**To** : Contracted AMO 145  
**CC** : GAM Accountable Manager, GAM Quality Assurance Manager  
**From** : Continuing Airworthiness Manager, GAM  
**Subject** : **9M-PMA Floatation Gas Bottle Pressure Limits Placard Reference**

AW139 9M-PMA S/N 31807

Figure 2-4 Flotation Gas Bottle Pressure Limits  
P/N 3G9560F00212 (Aerazur)

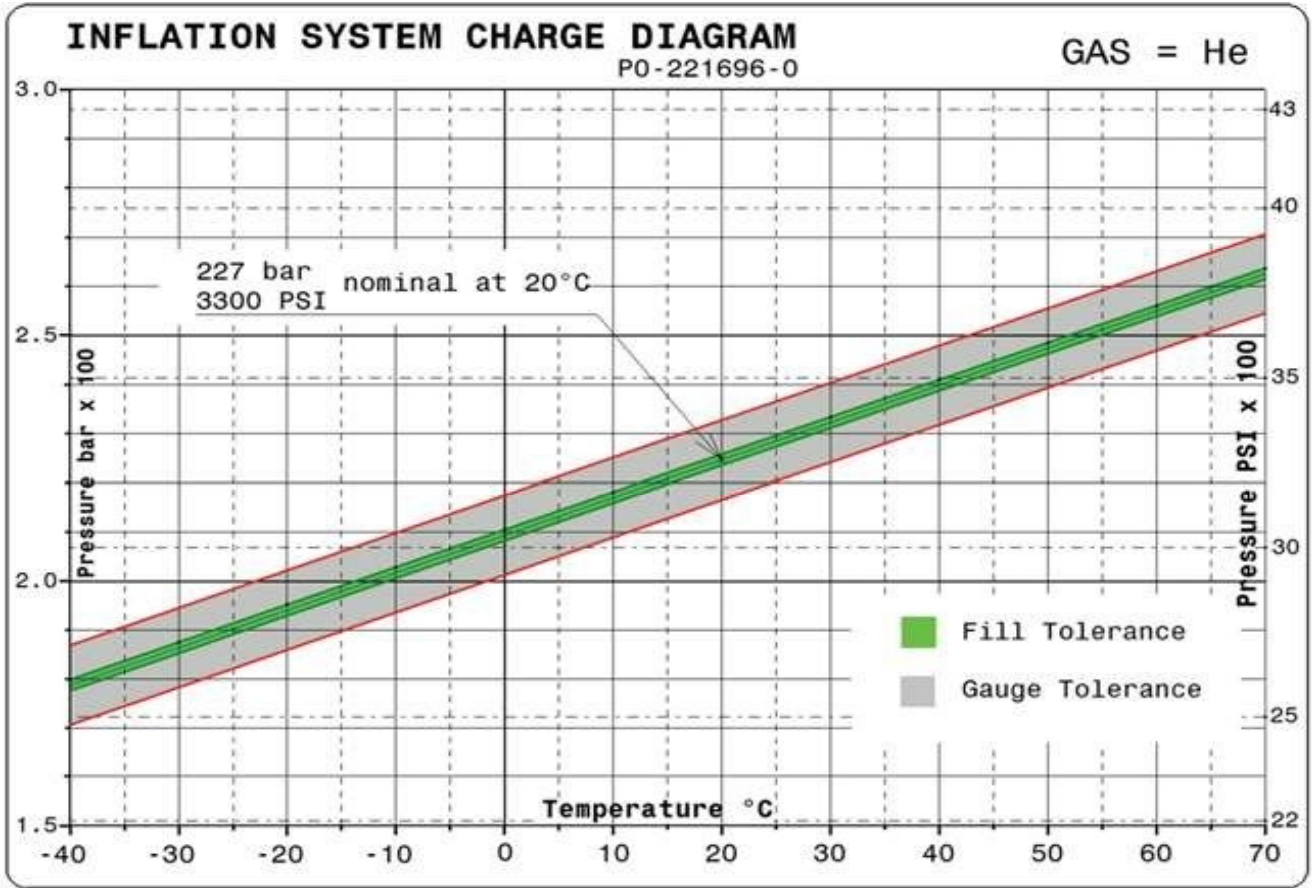
Gas Bottle Pressure Limits placards fitted on the float cover have been removed due to incorrect placard model fitted. Previously, placards fitted on the aircraft is for Aerosekur float model, however the correct placards should be as per AW139 RFM Supplement 9, Page S9-6F, Figure 2-4 as the aircraft is installed with Aerazur float model.

This notice is issued as a temporary instruction for contracted AMO maintaining AW139 9M-PMA S/N 31807 to use graph on the AW139 RFM Supplement 9, Page S9-6F, Figure 2-4 latest revision for checking the pressure of the float gas bottle until the new ordered placards arrived and installed.

- a) Contracted AMO 145  
To use AW139 RFM Supplement 9, Page S9-6F, Figure 2-4 as attached or latest revision as reference to check the pressure of the float gas bottle when fitted on the 9M-PMA S/N 31807 aircraft
